DOCUMENT 009113 - ADDENDA

- A. Addendum No. Two.

- A. Project Name: Skatium Locker Room Renovation.
- B. Owner: Township of Haverford.
- C. Owner's Representative: C.B. Development Services, Inc.
- D. Architect: BKP Architects.
- E. Date of Addendum: October 4, 2024

Skatium Locker Room Renovation
Responses to Bidder Questions and Written Identification of Modifications to Project Documents

DRAWING NO:
A-602

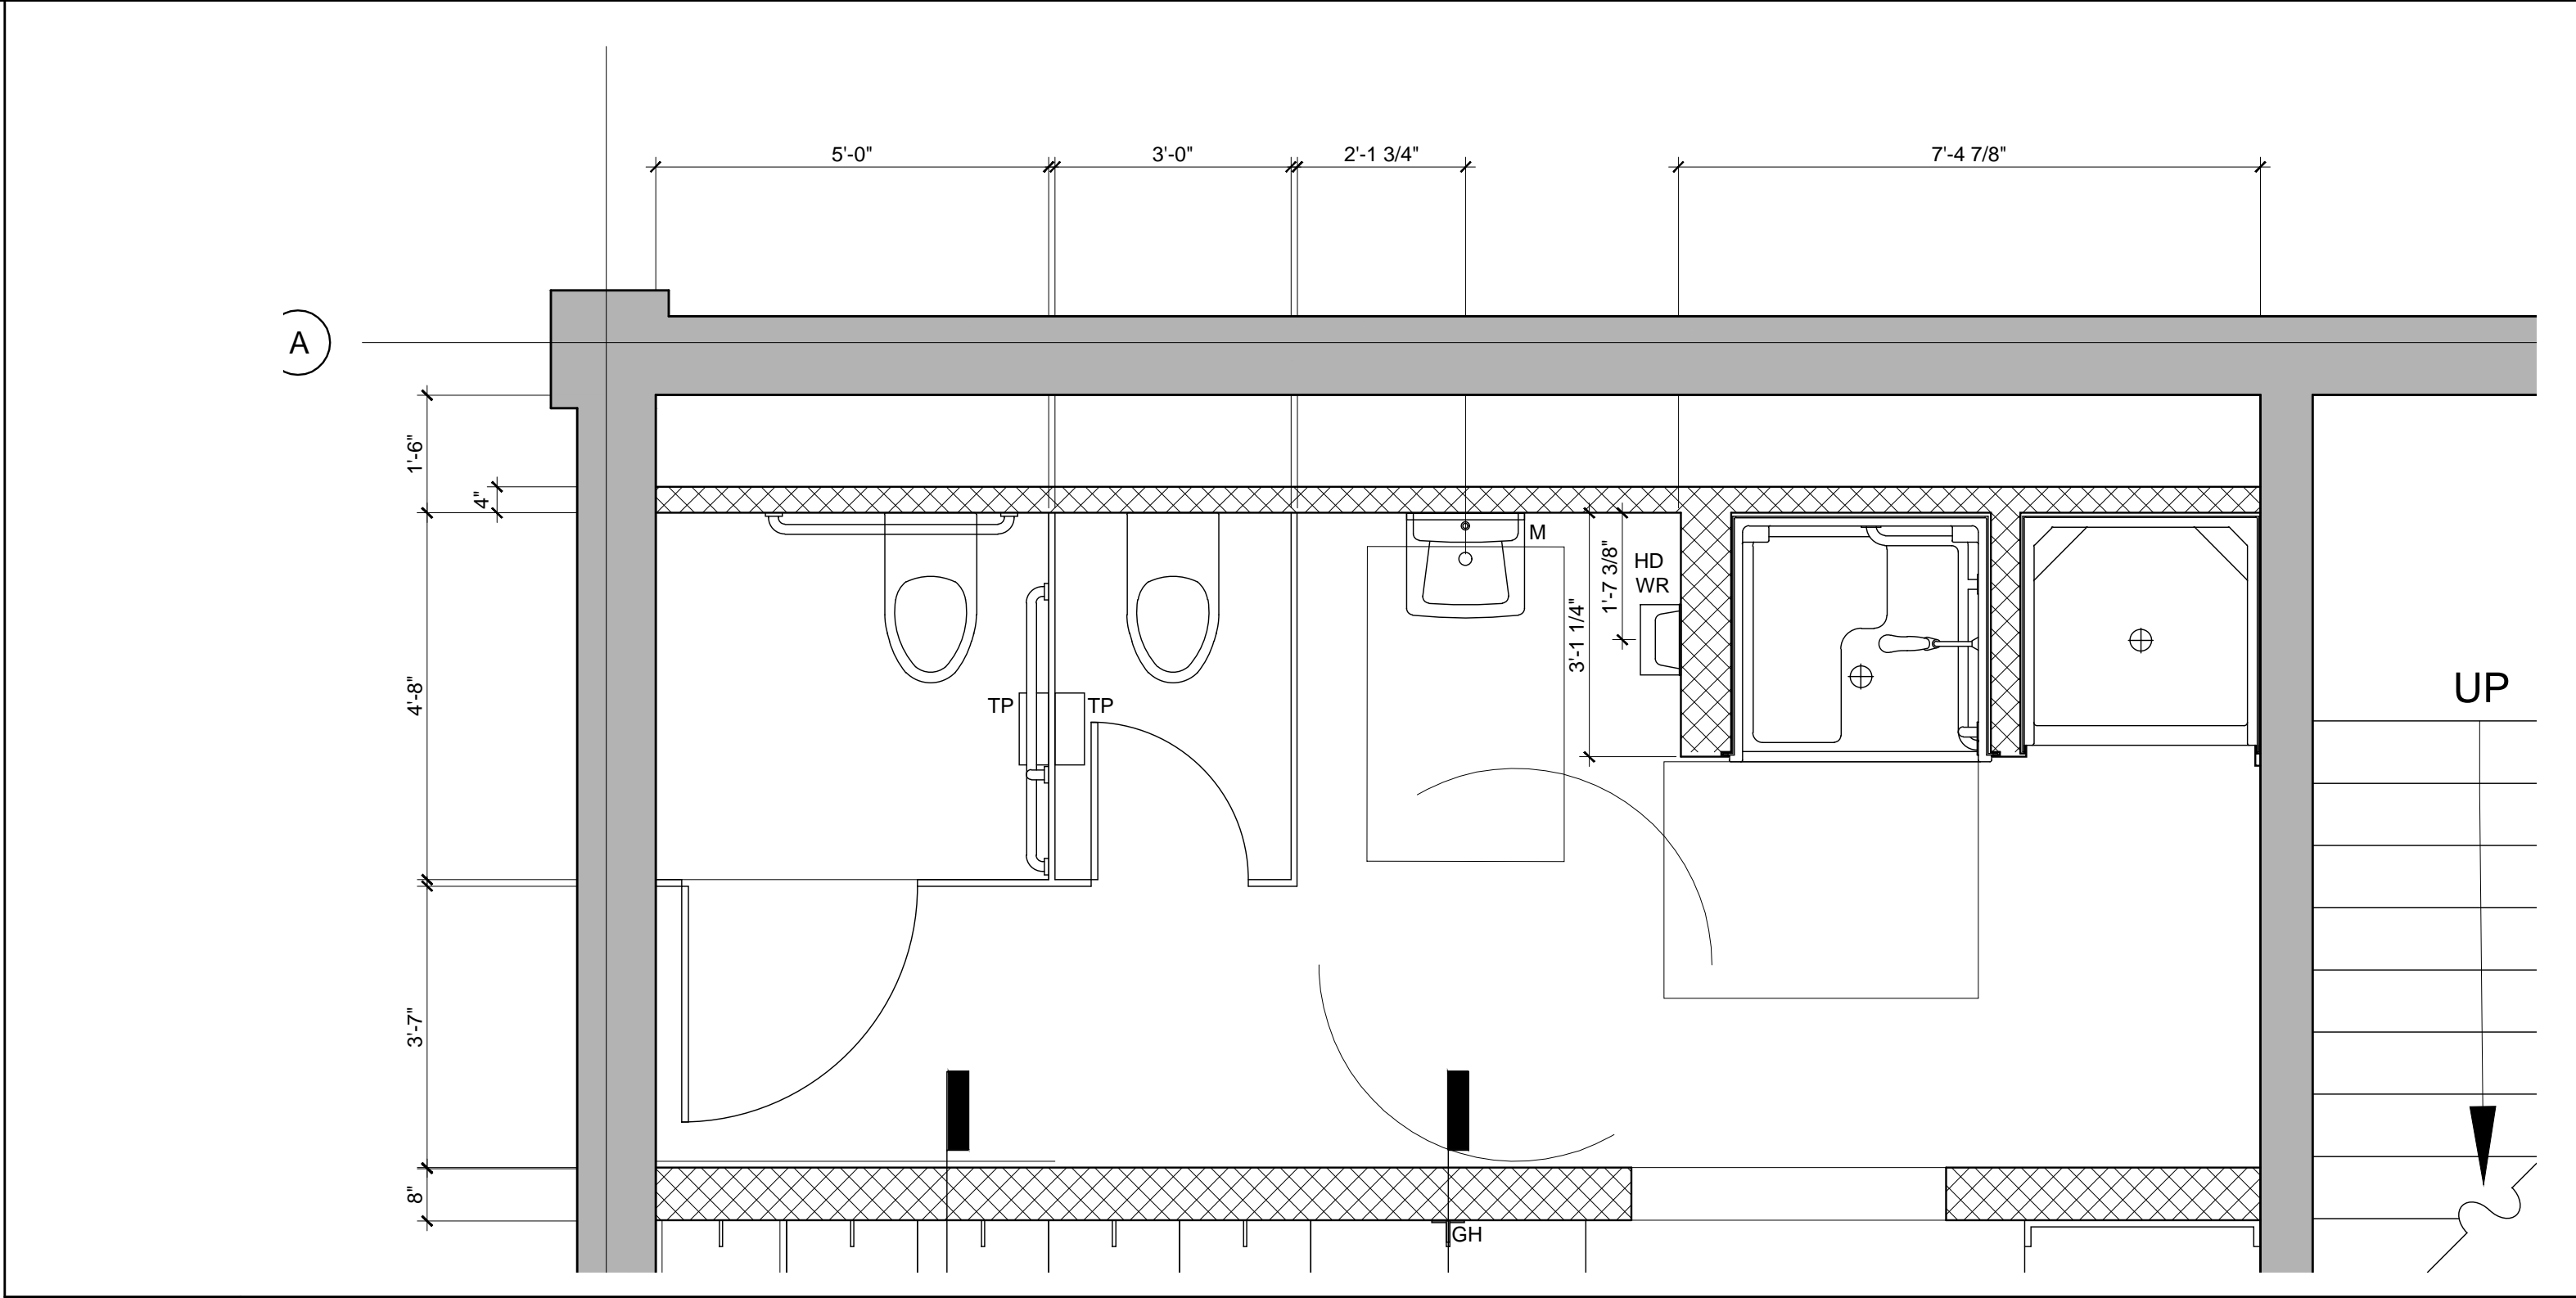
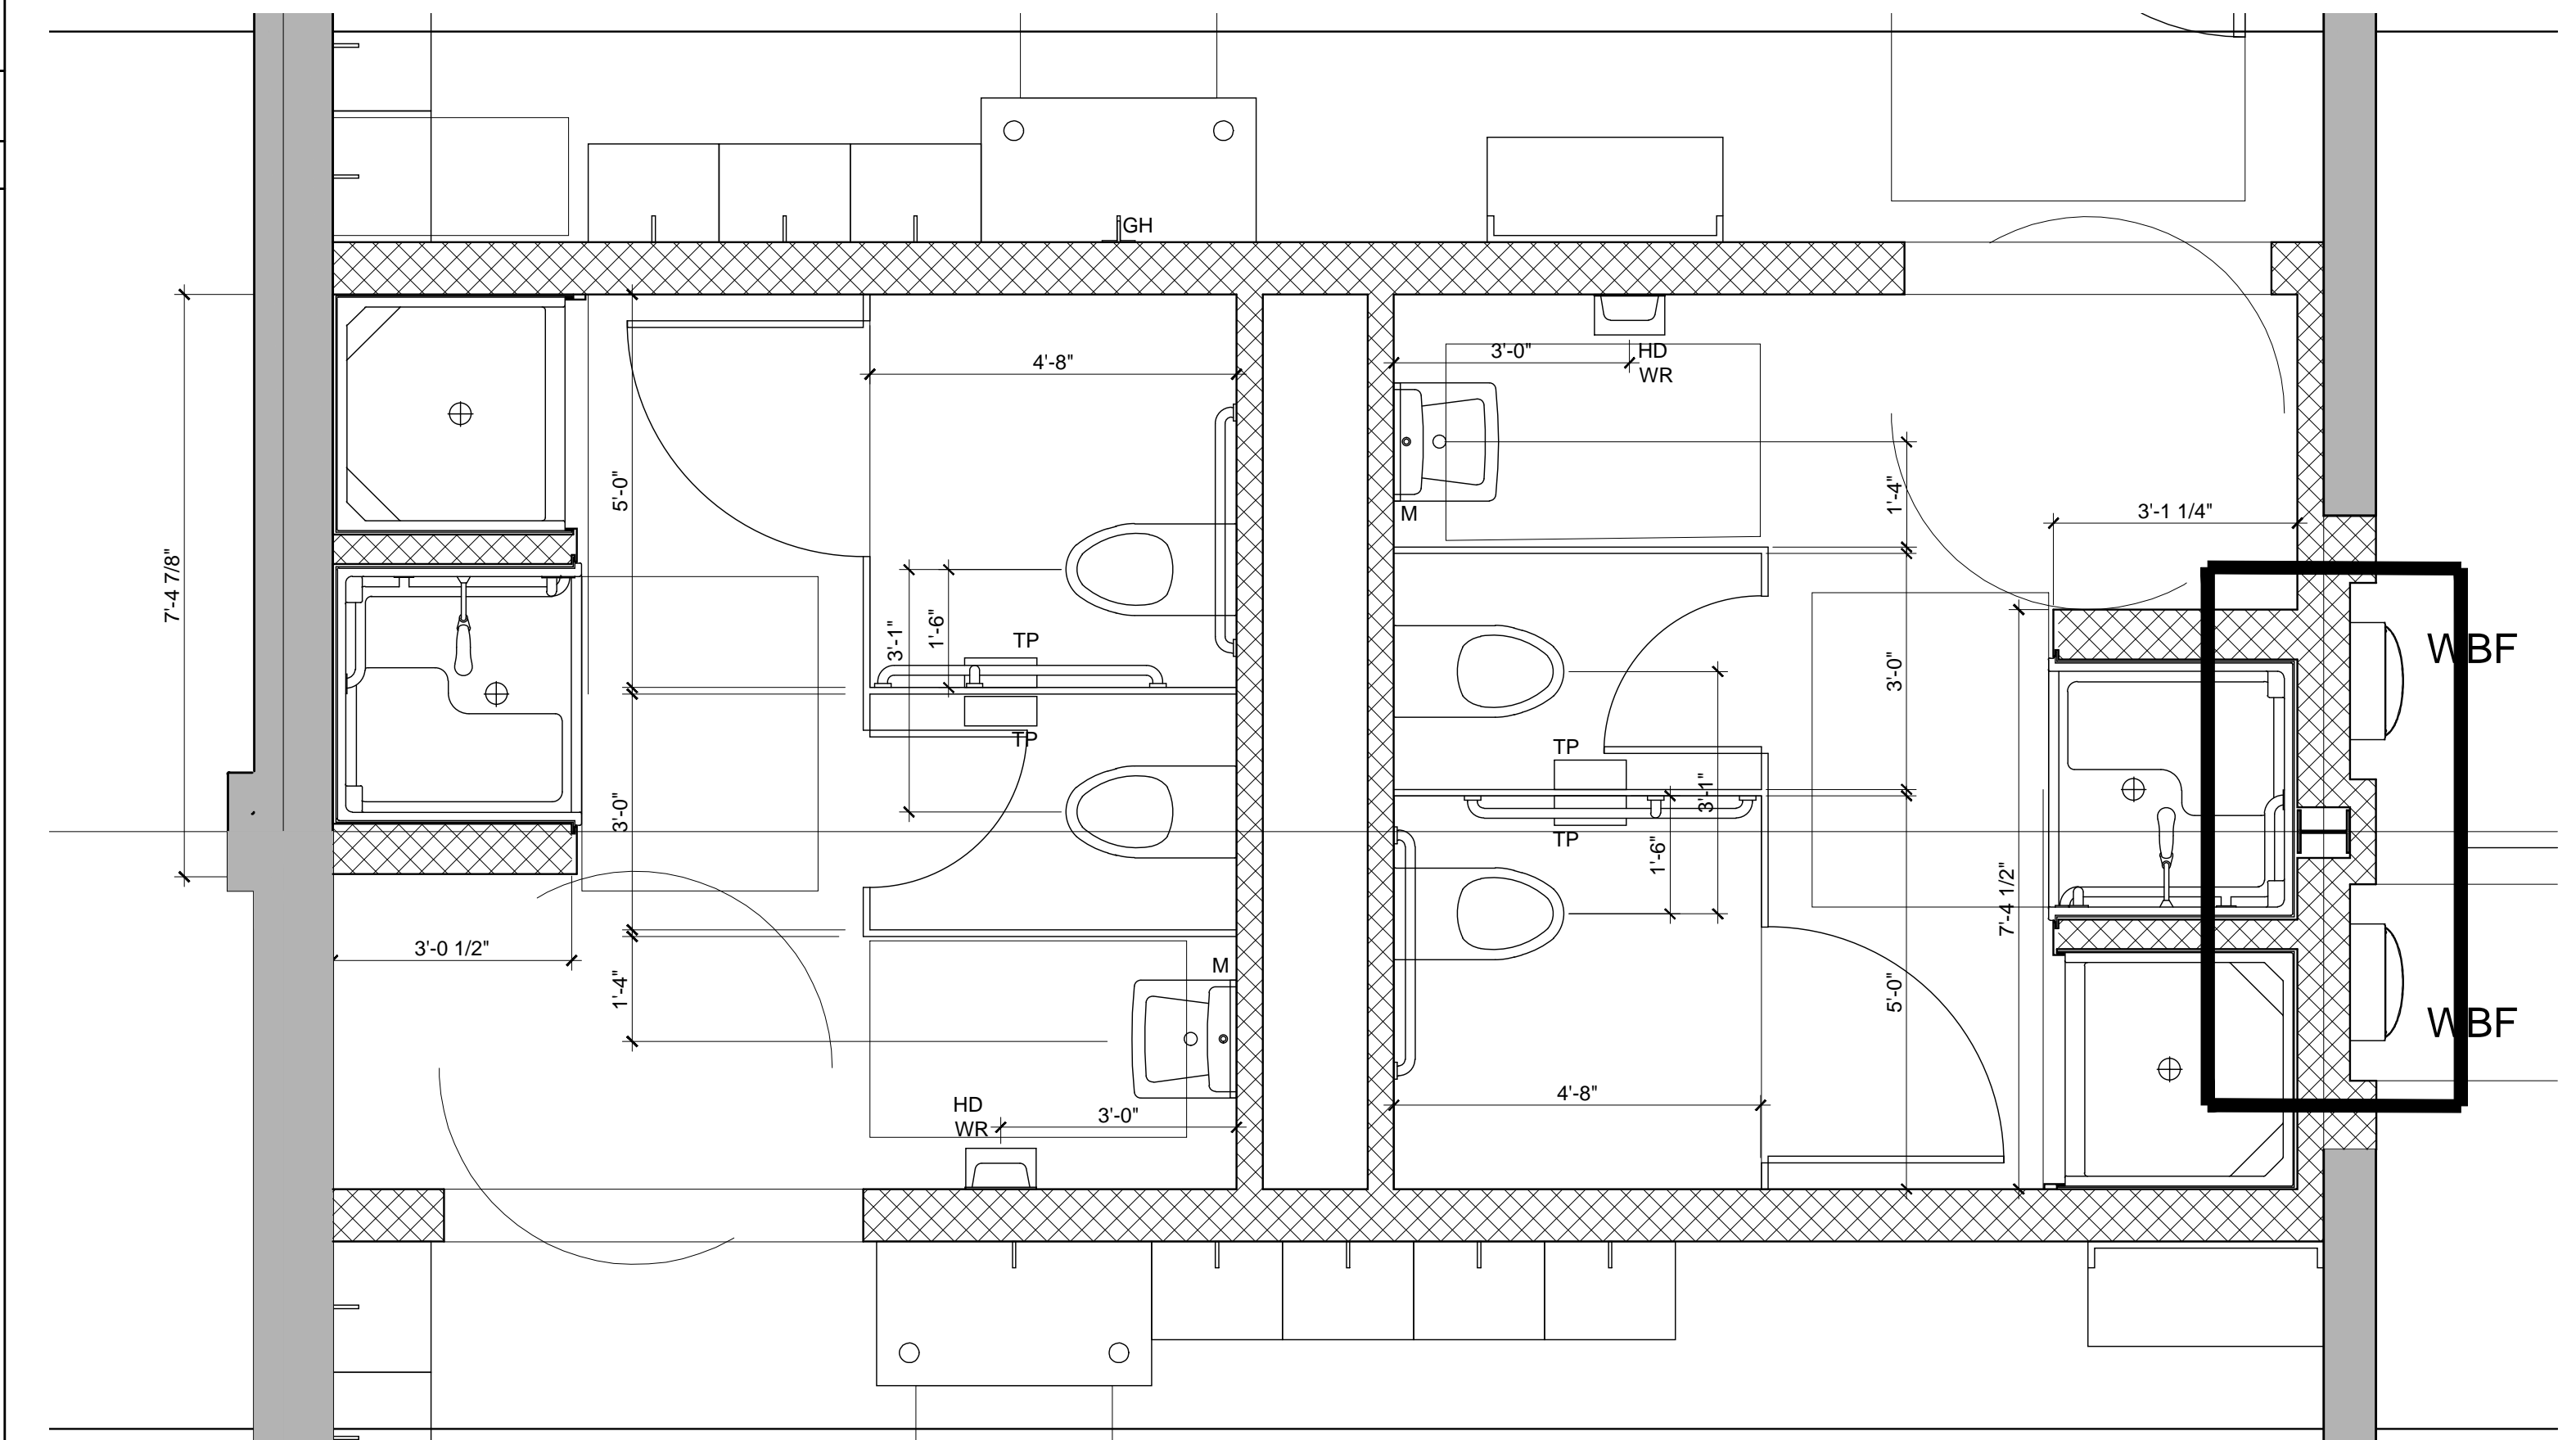
8. Several sheets reference Sheet A-100 which does not exist. Please advise.

- K. Drawing A-602 has been modified, removing references to Sheet A-100, replaced with reference to Sheet A-701.

Reference to Sheet A-100 should have been A-701. Drawing sheets A-601 and A-602, which are affected by this change have been revised and issued with Addendum #2.
